## SERVICE TECHNICAL INFORMATION

UTSUNOMIYA, JUNE 15, 1997  
 REF. NO.: S1-97-014  
 CUSTOMER RELATIONS & SERVICE DIV.

### ONE POINT REPAIR

**MODELS:** NSX-V100  
**SUBJECT:** Strange noise emitted from the speaker when playing a CD  
**SYMPTOM:** For the above model, there are cases in which a strange sound can be heard from the speaker when playing a CD. When such a symptom is indicated by the customer, perform the remedy described below.

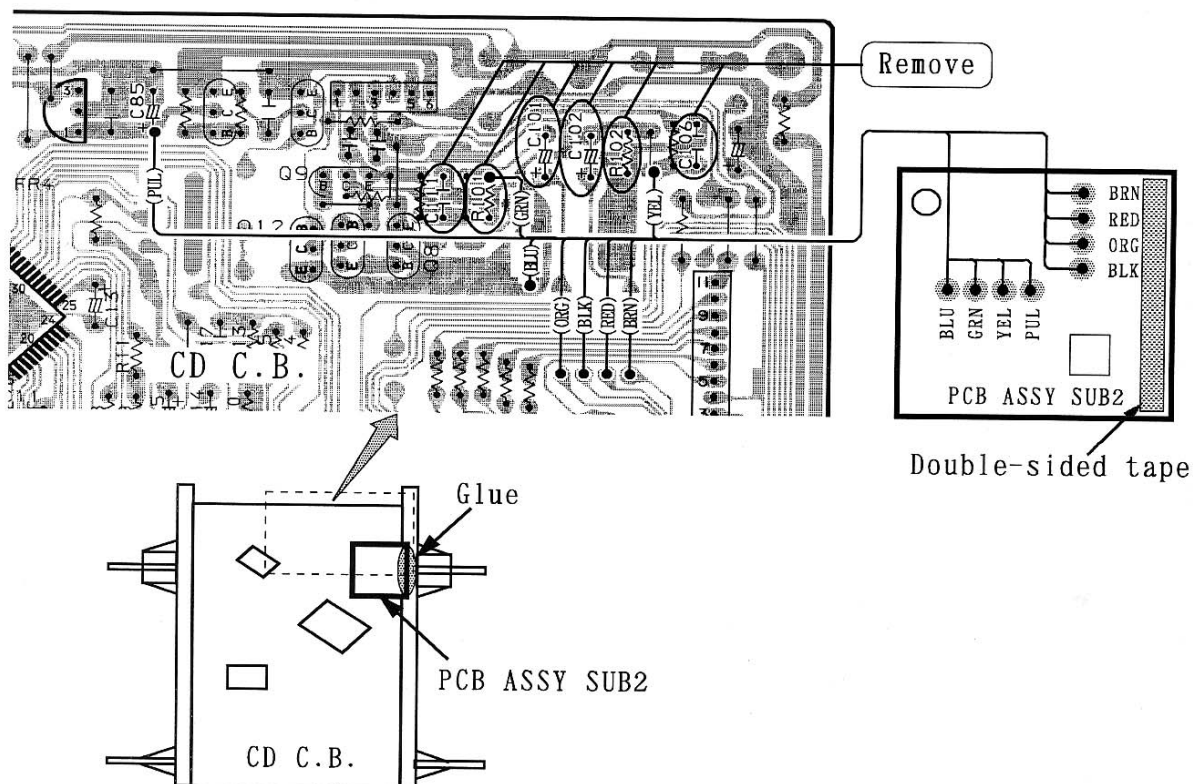
- REMEDY:** Following the steps below, attach the child board (PWB ASSY SUB2).
- 1) Remove the 2 resistors (R101, R102) and 4 condensers (C101, C102, C106, C111) from the child board CD C.B.
  - 2) Solder the 8 child board wires to CD C.B.
  - 3) Using double-sided tape, attach the child board to the CD chassis and secure it with glue.

**Note:** Care must be taken so that the electrolytic capacitor connected on the child board does not come into contact with the CD C.B. land.
